URBAN DESIGN COMMITTEE

2. [Antelope Tower Redevelopment](#) – *UDR22128*

The Antelope Tower Redevelopment project has been before the Committee several times. The initial redevelopment project was reviewed by UDC in [March 2020](#), [April 2020](#), and [June 2020](#). Reviews included the landscaping and patio space along Antelope Valley Parkway. More recently, the developer appeared before UDC in [June 2022](#), proposing to enclose a portion of the outdoor patio space for their first floor restaurant tenant on the west side of the building. As noted back in June, this is a significant change to what was previously approved. Thus, UDC's advice is being sought on the use of Tax Increment Financing.

EARLY BIRD TENANT FINISH
HOPPE DEVELOPMENT
1800 K STREET, SUITE 100
LINCOLN, NE

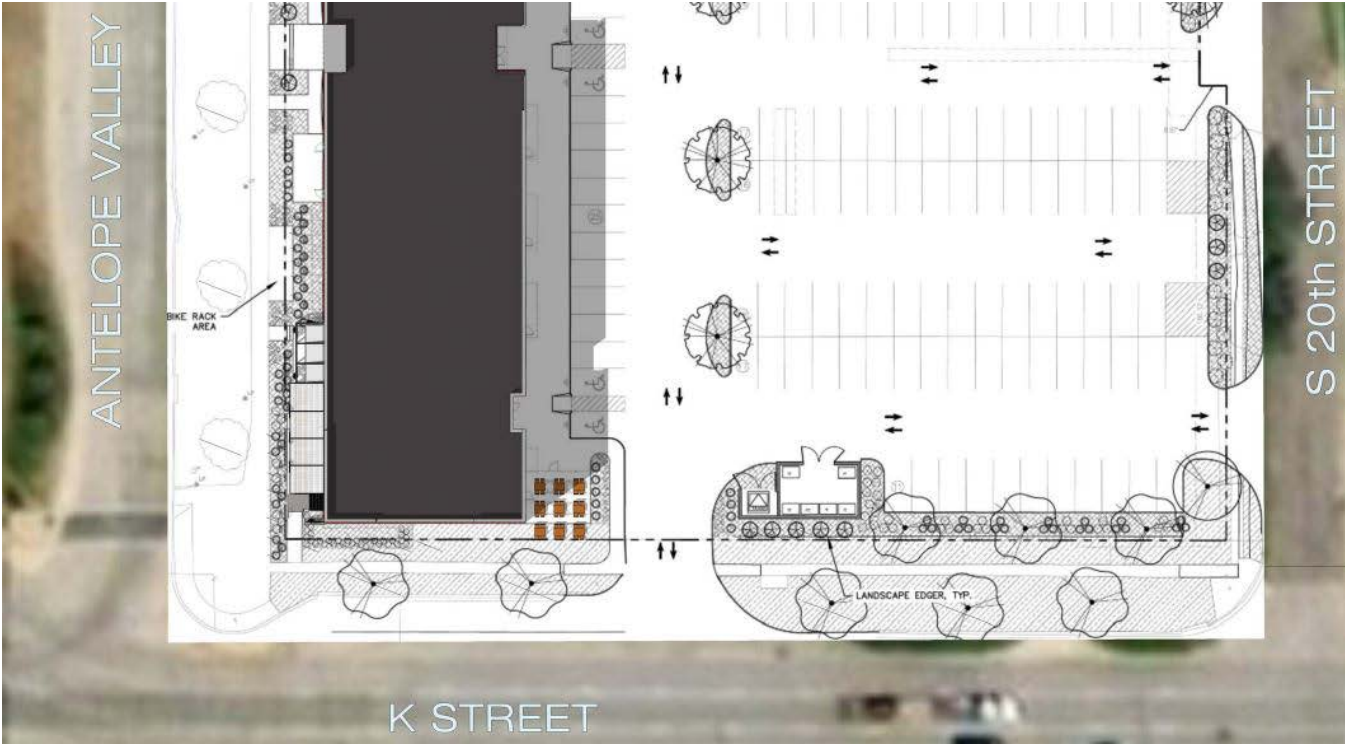
- 1) The cooler is now enclosed with a structure or frame that is complementary to the primary patio enclosure.
- 2) Overhangs have been added to the roof.
- 3) The roof design has been modified to incorporate a less opaque appearance through the use of a translucent roofing system.

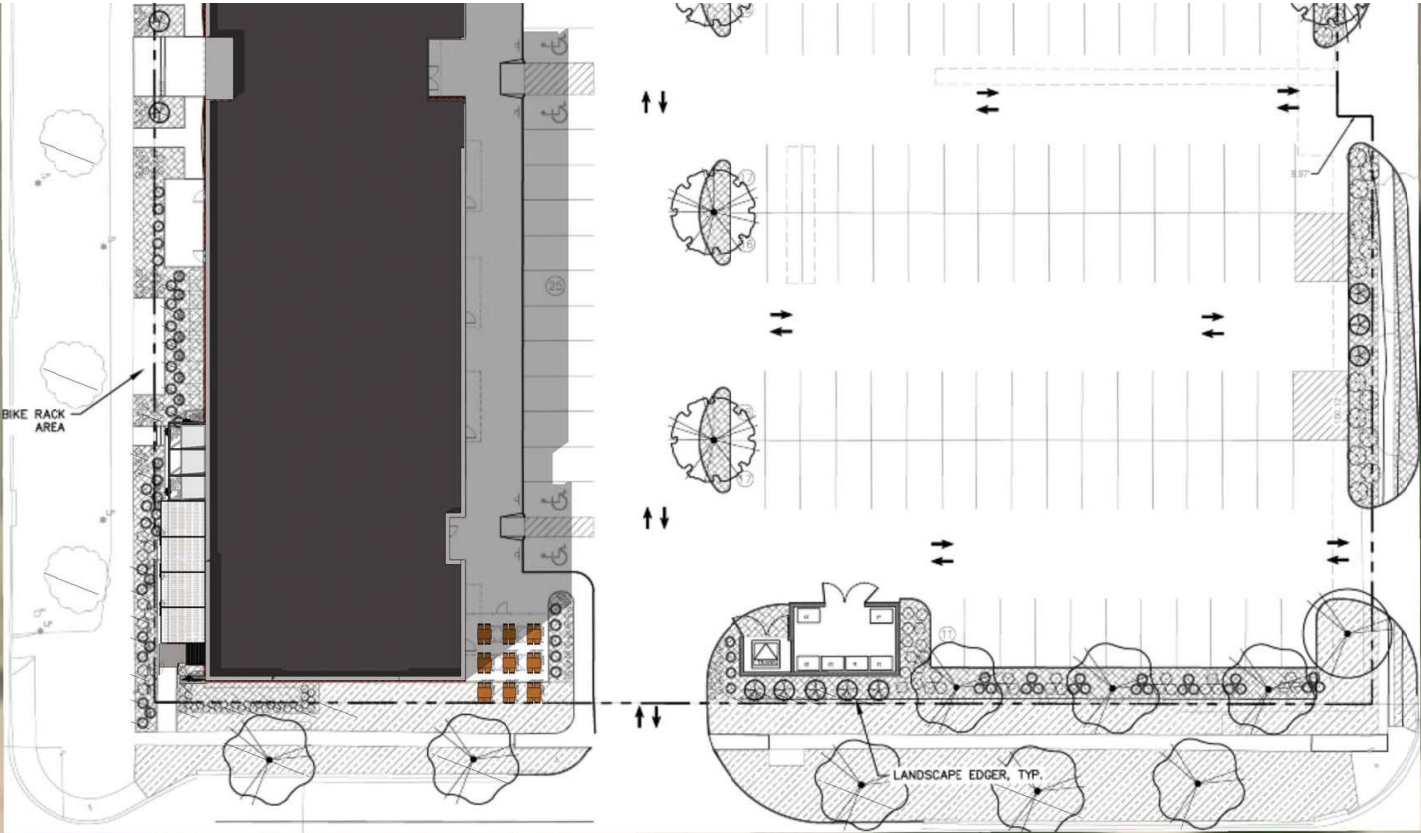
Hind asked about the large box depicted next to the patio space. David Wiebe stated he is working on the plan and the covered patio addition. The large box is a cooler. They are proposing

Grasso stated this could be a good prototype that is somewhat extended in a thoughtful way across the whole street front. She would plan on some roller shades or some way to get some shade.

Hind believes this should come back next month with a little more refinement on the design.

Canney doesn't want to discourage the tenant. Grasso agreed. Huston believes this could be approved subject to a final review of the design.

Grasso asked if anything was going on with the east side. Wiebe stated there will be outdoor seating. Approve in concept with review of the design.
